Docket No. 50-443
[NYN-02093](#)

Seabrook Station
License Amendment Request 02-04
“Revision To Technical Specifications Associated With Pressure/Temperature
Curves and Low Temperature Overpressure Protection Limits”

SEABROOK STATION UNIT 1

**License Amendment Request 02-04,
"Revision To Technical Specifications Associated With Pressure/Temperature Curves
and Low Temperature Overpressure Protection Limits"**

FIGURE 3.4-2
REACTOR COOLANT SYSTEM HEATUP LIMITATIONS - APPLICABLE UP TO 20 EFPY

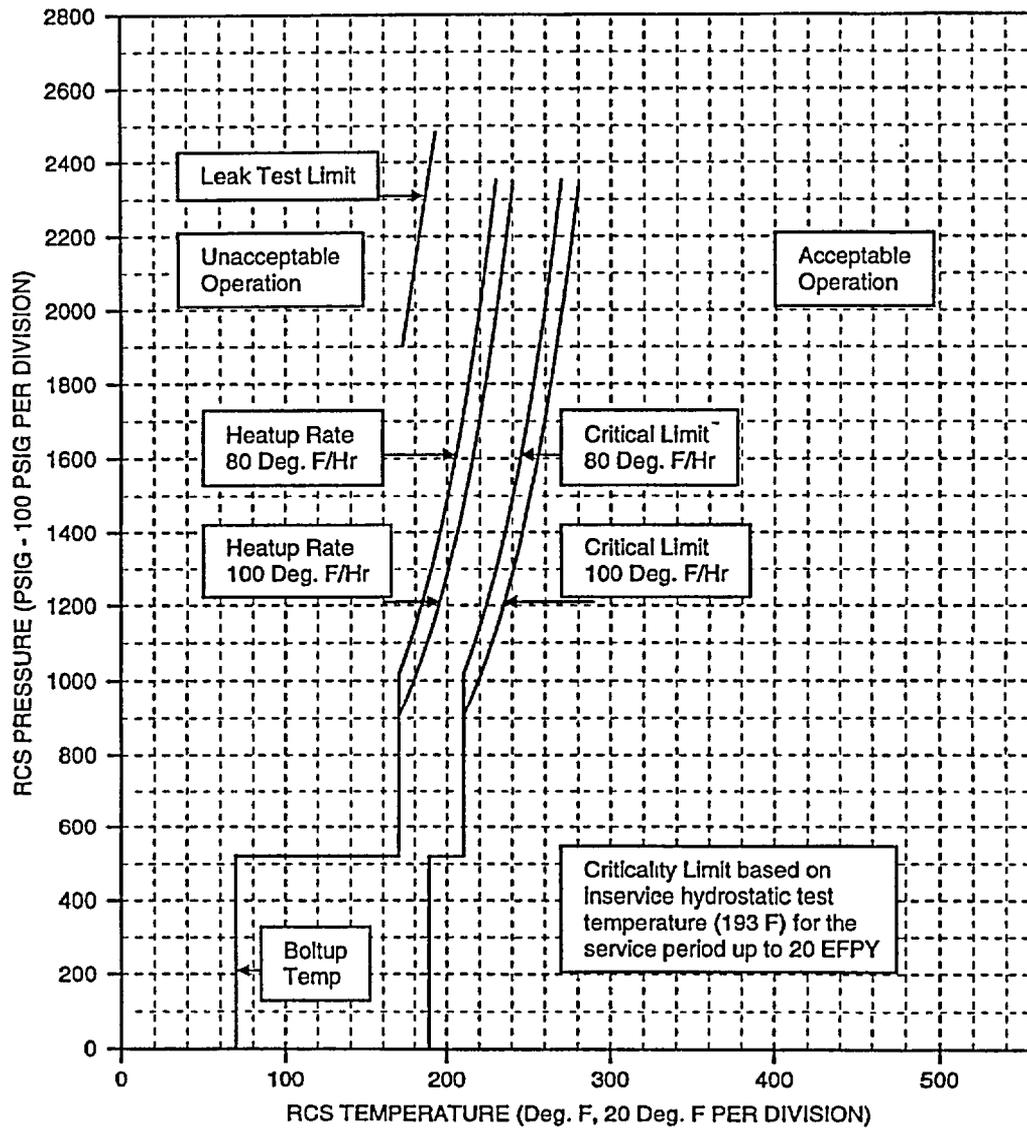
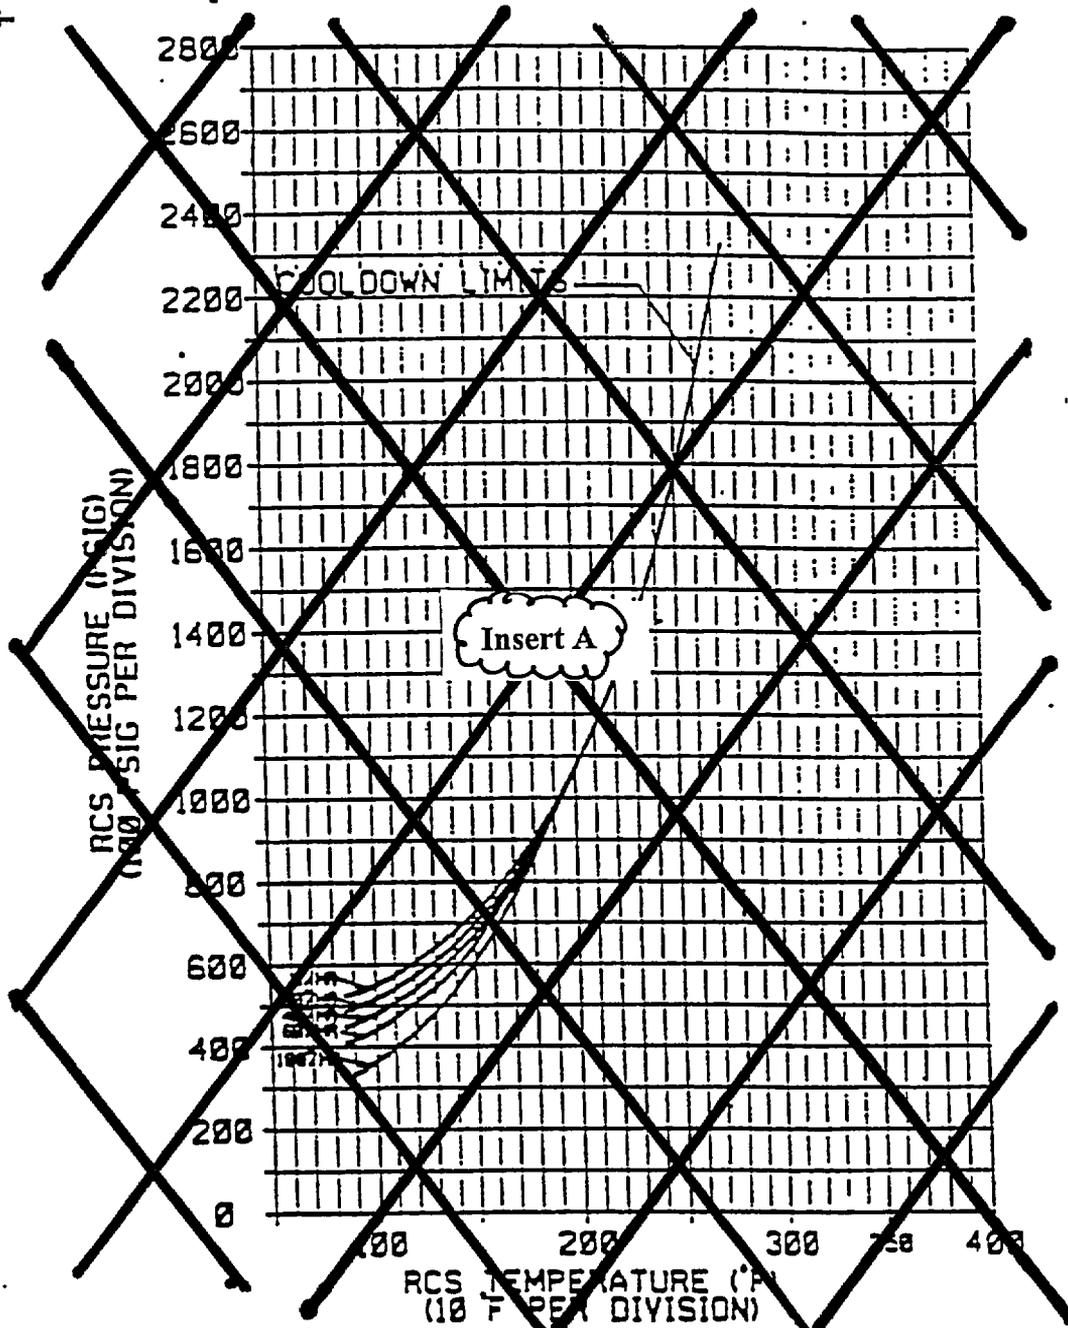
~~FIGURE 3-4-2~~

Curves applicable for the first 20 EFPY and contain margins of 20°F and 100 psig for possible instrument errors

~~MATERIAL PROPERTY BASIS~~

~~Controlling material: Base metal~~
~~Copper content: 0.06 wt%~~
~~RT initial: 40°F~~
~~RT NDT after 11.1 EFPY: 1/4T, 108°F~~
~~RT NDT: 3/4T, 86°F~~

FIGURE 3.4-3
REACTOR COOLANT SYSTEM COOLDOWN LIMITATIONS - APPLICABLE UP TO 20 EFPHY

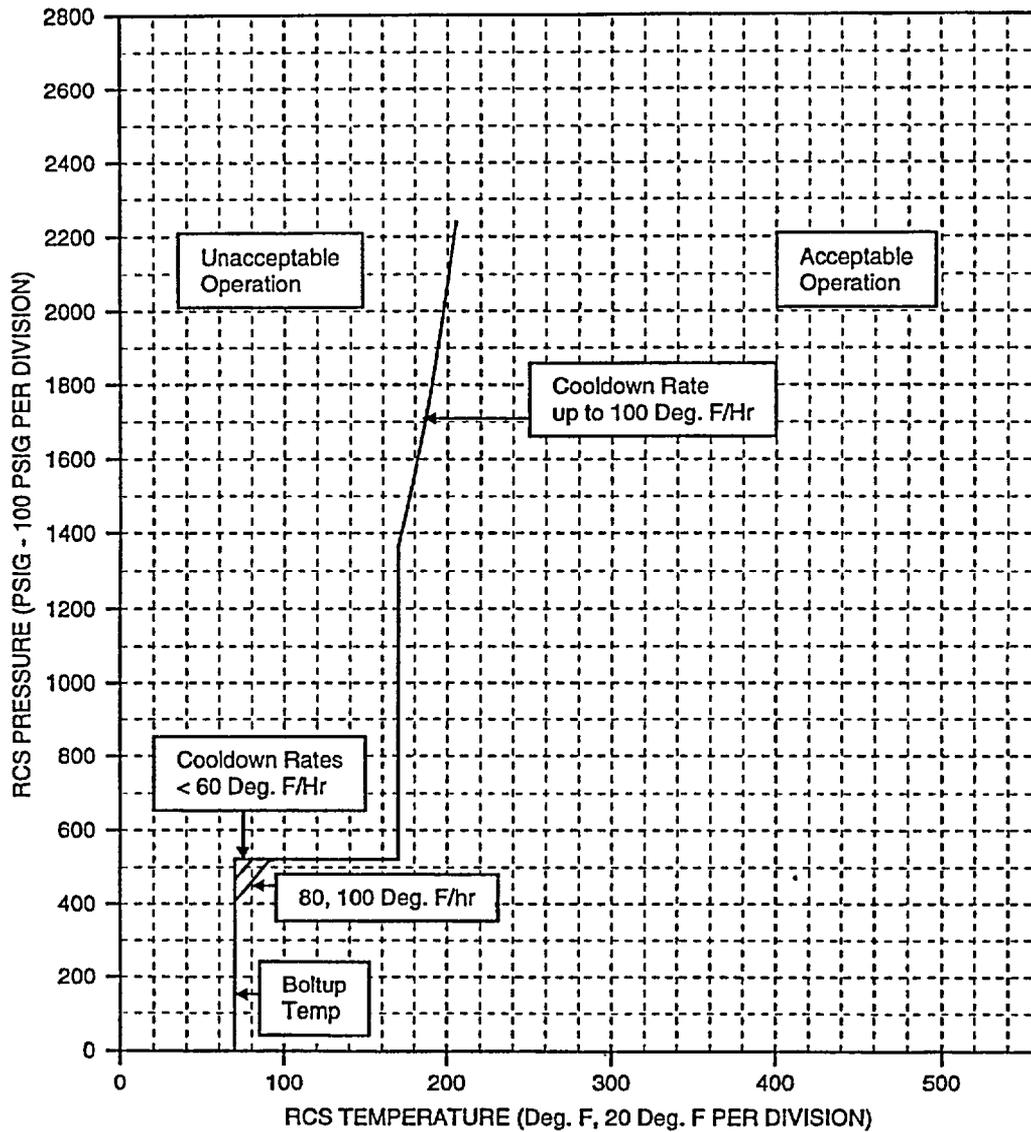
~~FIGURE 3.4-3~~

Curves applicable for the first 20 EFPHY and contain margins of 20°F and 100 psig for possible instrument errors

FIGURE 3.4-4 RCS COLD OVERPRESSURE PROTECTION SETPOINTS

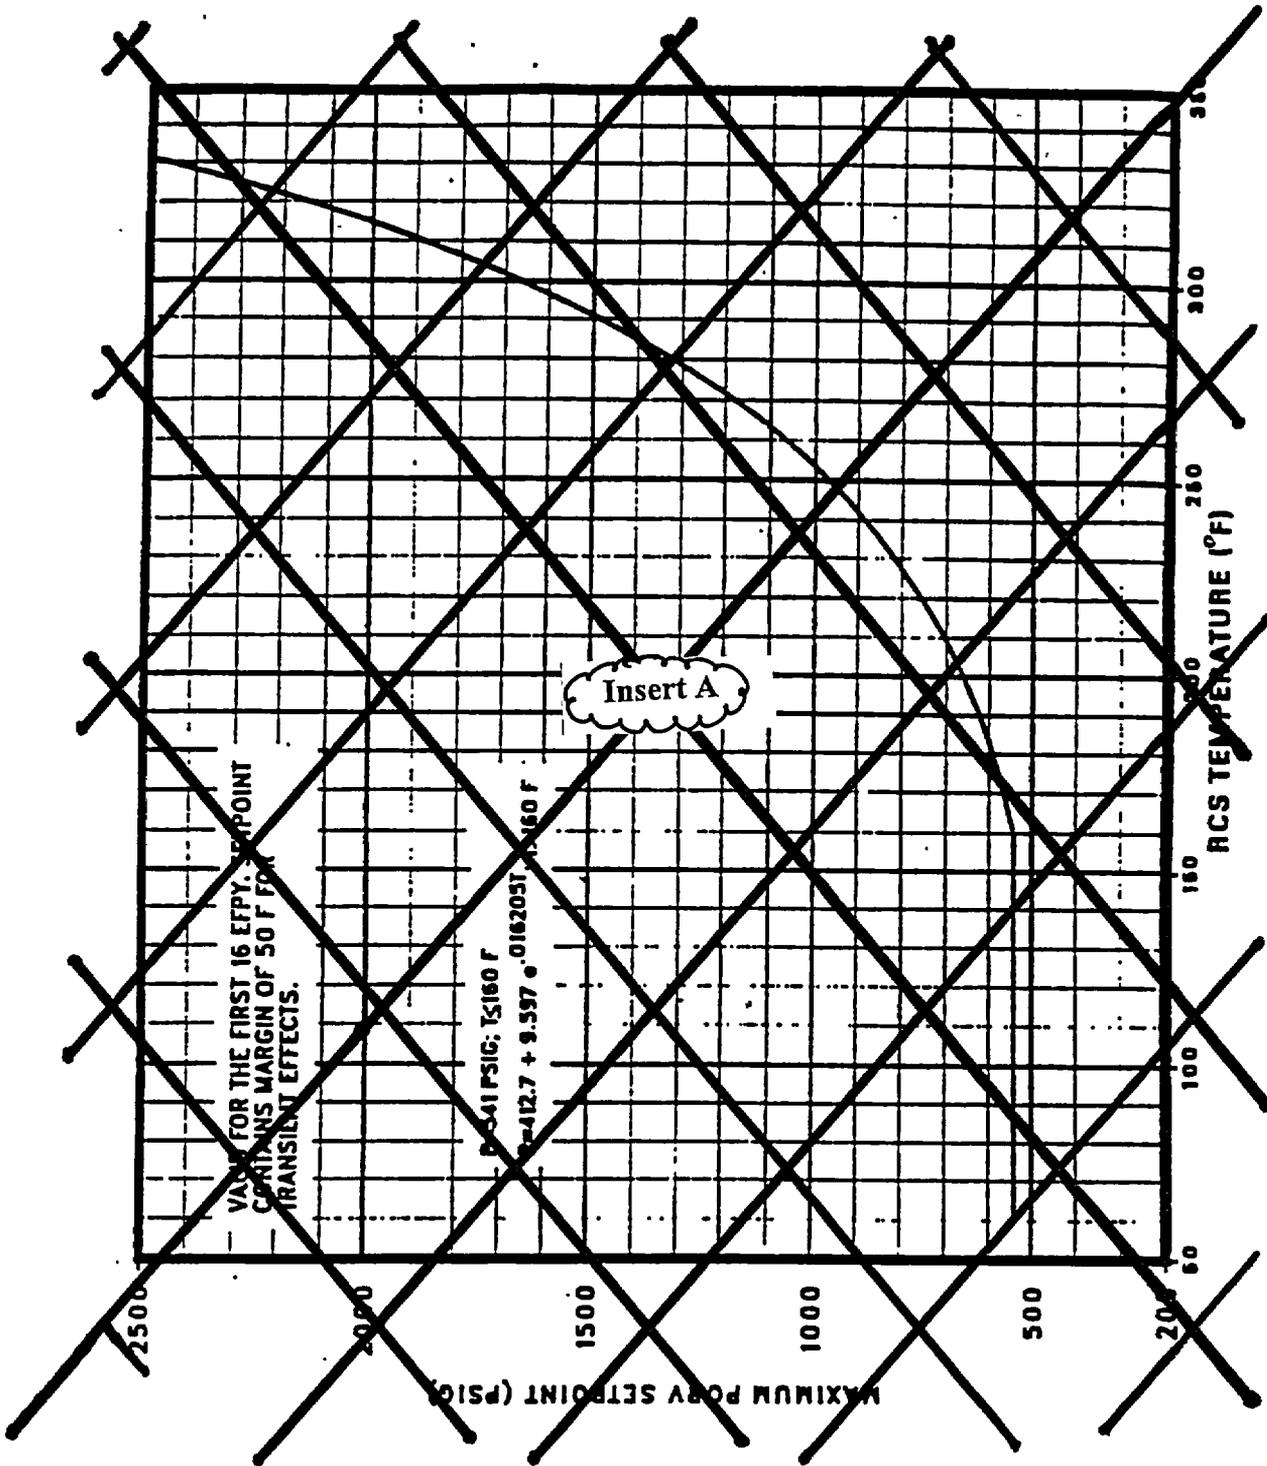
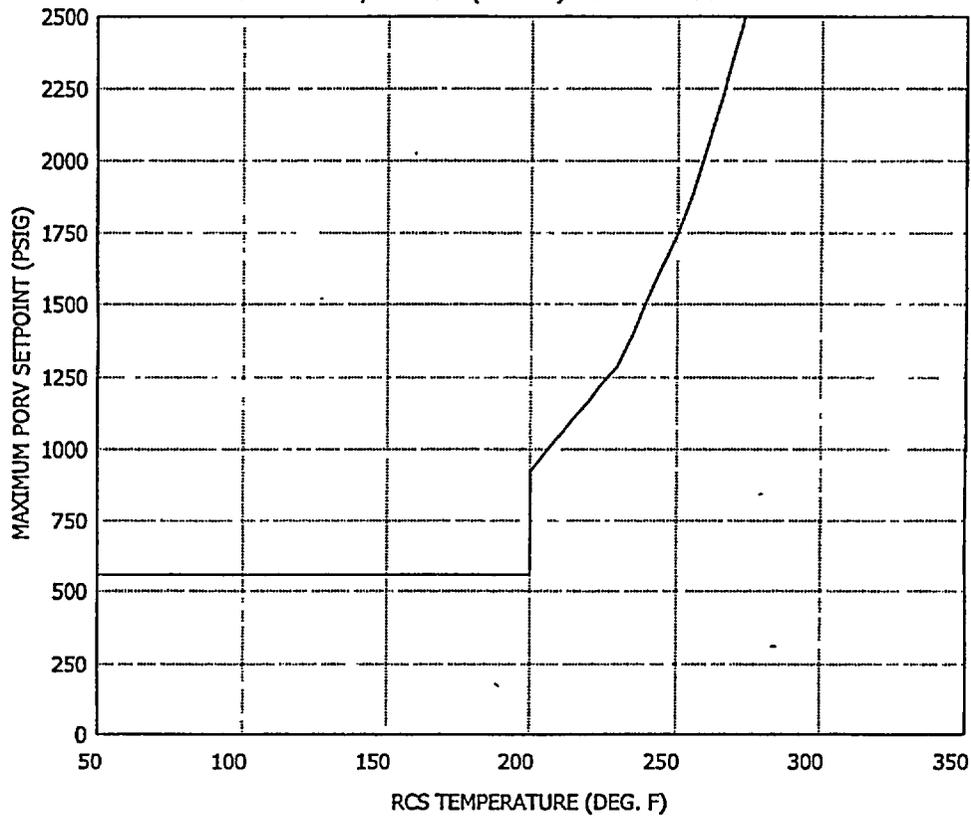
FIGURE 3-4-4 RCS COLD-OVERPRESSURE-PROTECTION-SETPOINTS

Insert A, Page 3/4 4-36

$$230.5^{\circ}\text{F} < T \leq 255.0^{\circ}\text{F}, P = 23.15*(T-230.5) + 1295.05 \text{ PSIG};$$

$$T > 255.0^{\circ}\text{F}, P = 34.5*(T-255.0) + 1862.225 \text{ PSIG}$$
